DESIGN <i>[Signature]</i>	DRAWN BY <i>[Signature]</i>	DART AEROSPACE LTD HAWKESBURY, ONTARIO, CANADA	
CHECKED <i>[Signature]</i>	APPROVED <i>[Signature]</i>	DRAWING NO. DEO 9251	REV. A SHEET 1 OF 1
DATE 03.02.19		TITLE BRACKET MODIFICATION	SCALE NTS
A	03.02.19	NEW ISSUE

## DART ENGINEERING ORDER

TO AMEND BHA/DRA/358-02-01 REV. F

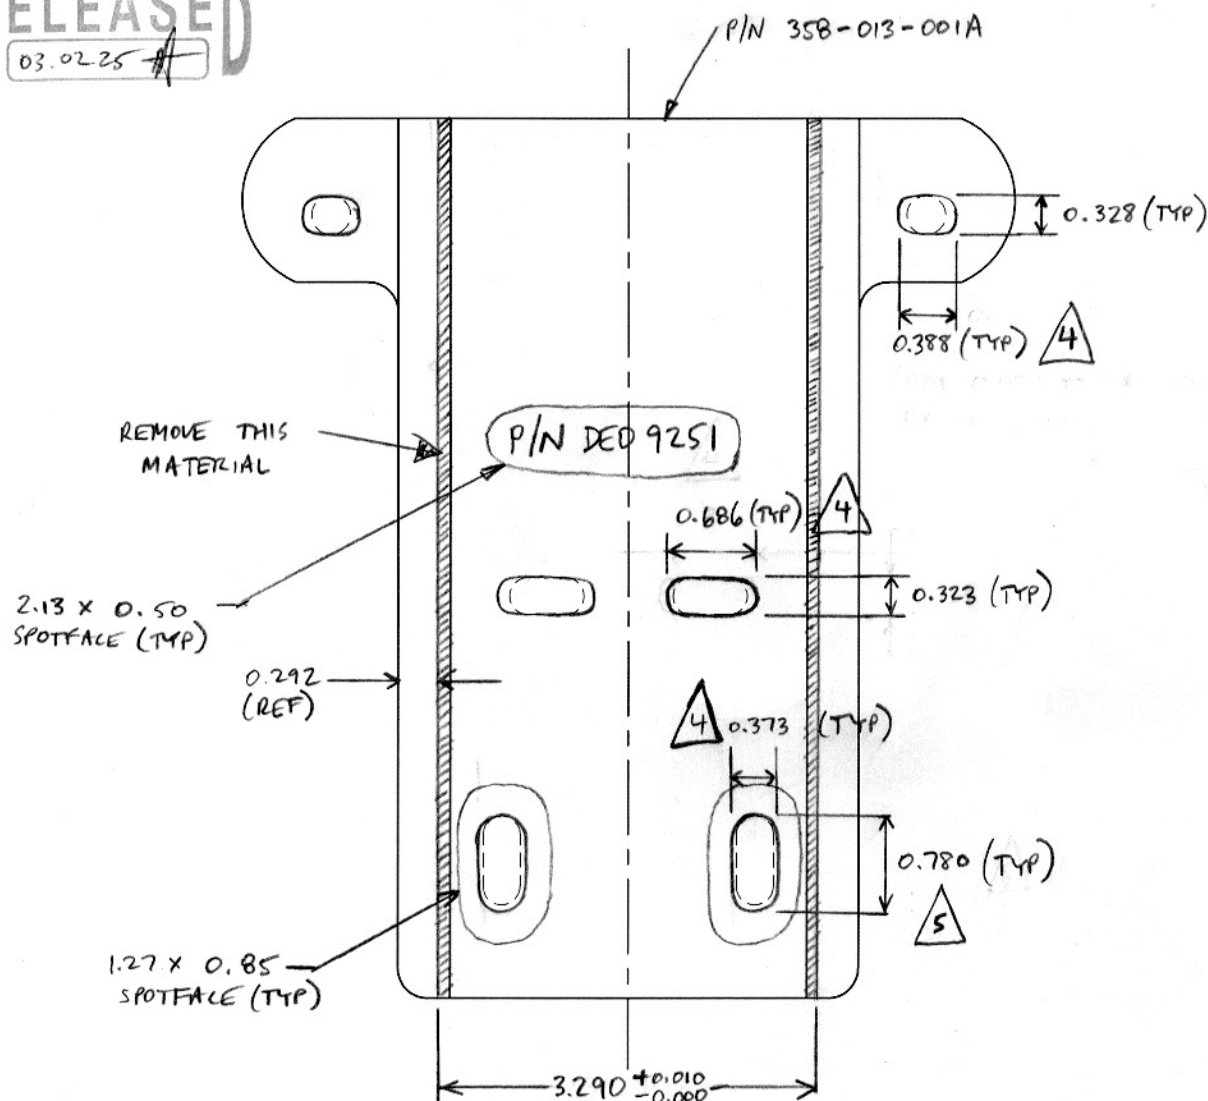
- NOTES:
- 1) IDENTIFY AS DEO 9251 AFTER MODIFICATION
  - 2) POWDER COAT WHITE (4.3.5.1) PER QSI DQS 4.3 AFTER MODIFICATION
  - 3) ALL SLOT DIMENSIONS ARE  $+0.010$   $-0.000$
  - 4) ADD 0.030 TO EACH SIDE OF EXISTING HOLE OR SLOT TO GET THIS DIM
  - 5) ADD 0.030 TO BOTTOM SIDE TO GET THIS DIM
